Architectural Review Board Staff Report

Project Type:	Amended Site Development Section Plan
Meeting Date:	November 14, 2019
From:	Mike Knight, Assistant City Planner <i>mk</i>
Location:	A 7.3 acre tract of land located northeast of the intersection of Wild Horse Creek Road and Old Chesterfield Road.
Description:	<u>Downtown Chesterfield Category C, Lot A (WILDHORSE) ASDSP:</u> An Amended Site Development Section Plan, Landscape Plan, Lighting Plan, Architectural Elevations and Architect's Statement of Design for a 7.3 acre tract of land located northeast of the intersection of Wild Horse Creek Road and Old Chesterfield Road.

Staff requests review and recommendation on this submittal for Downtown Chesterfield Category C, Lot A (WILDHORSE) Amended Site Development Section Plan.

NORTH ELEVATION

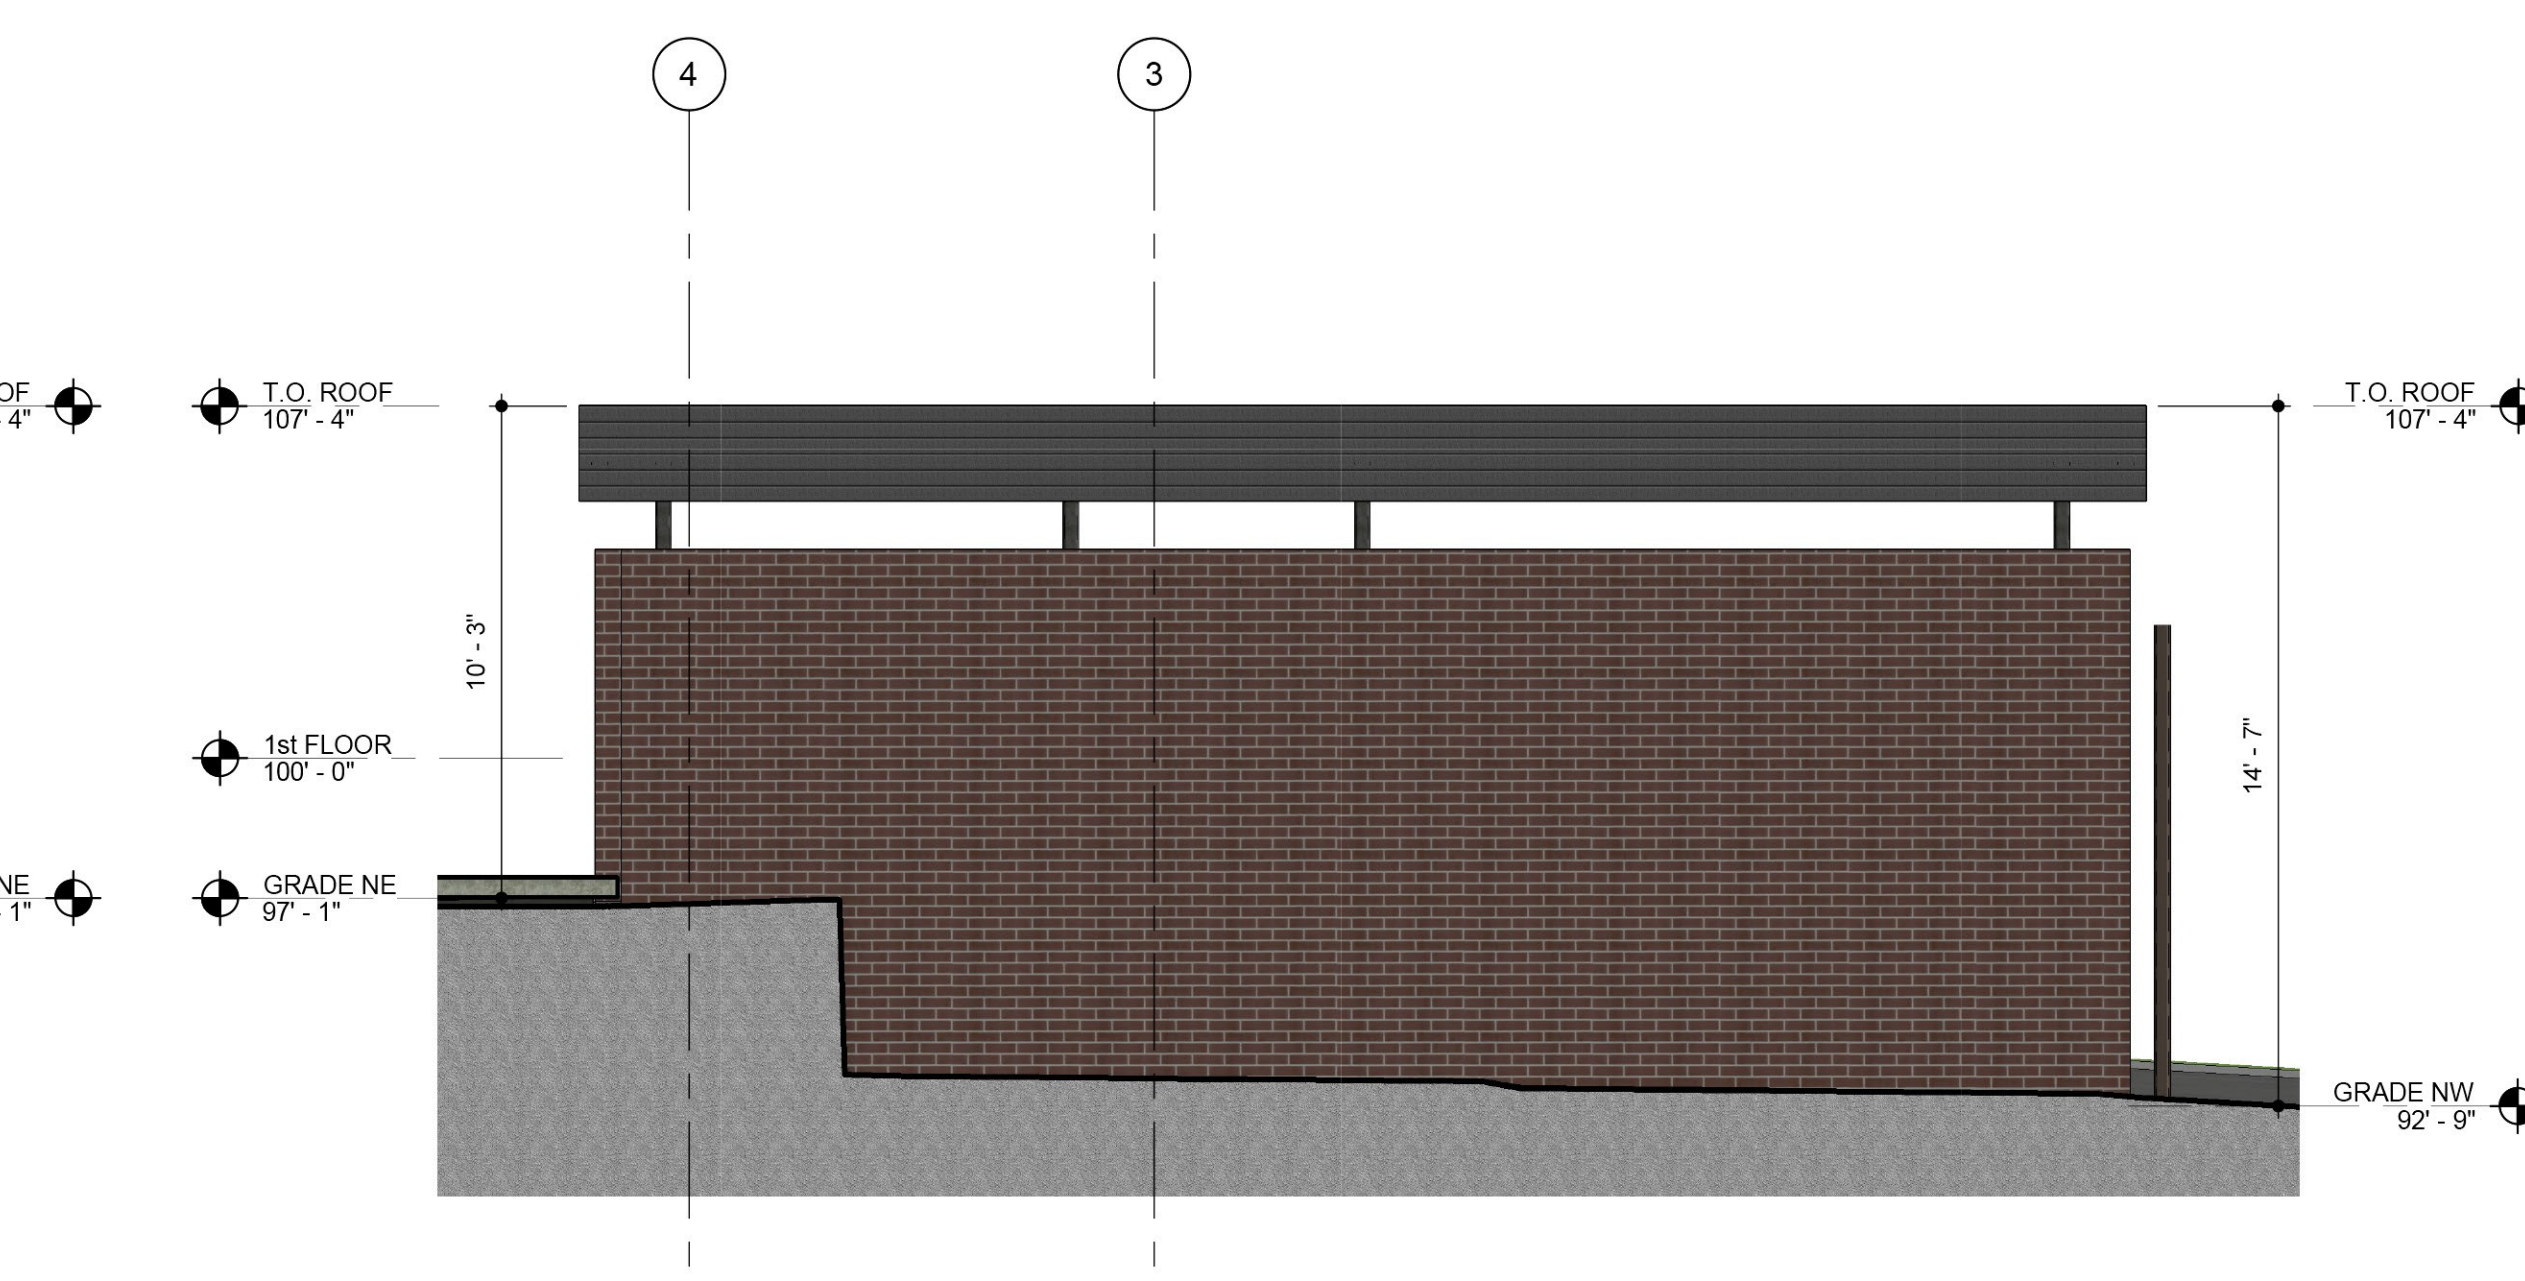
The footprint of the trash enclosure is largely the same. There are two main differences being proposed (Figure 4). The first is an additional metal panel on the top of the structure that is a similar feature to the metal panel located above the restaurant. The second is that the overall height of the enclosure is larger. The currently approved trash enclosure is 6' tall, while the new enclosure is roughly 14' tall including the metal feature depending on the grade change.

1. Openings in the north and west elevations of the garage have been revised to 1" insulated glass in aluminum storefront system, in lieu of, the previously approved fence material.
2. Metal louvers have been introduced on the north and west elevations of the garage. The intent is to paint the louvers to match the adjacent building material.
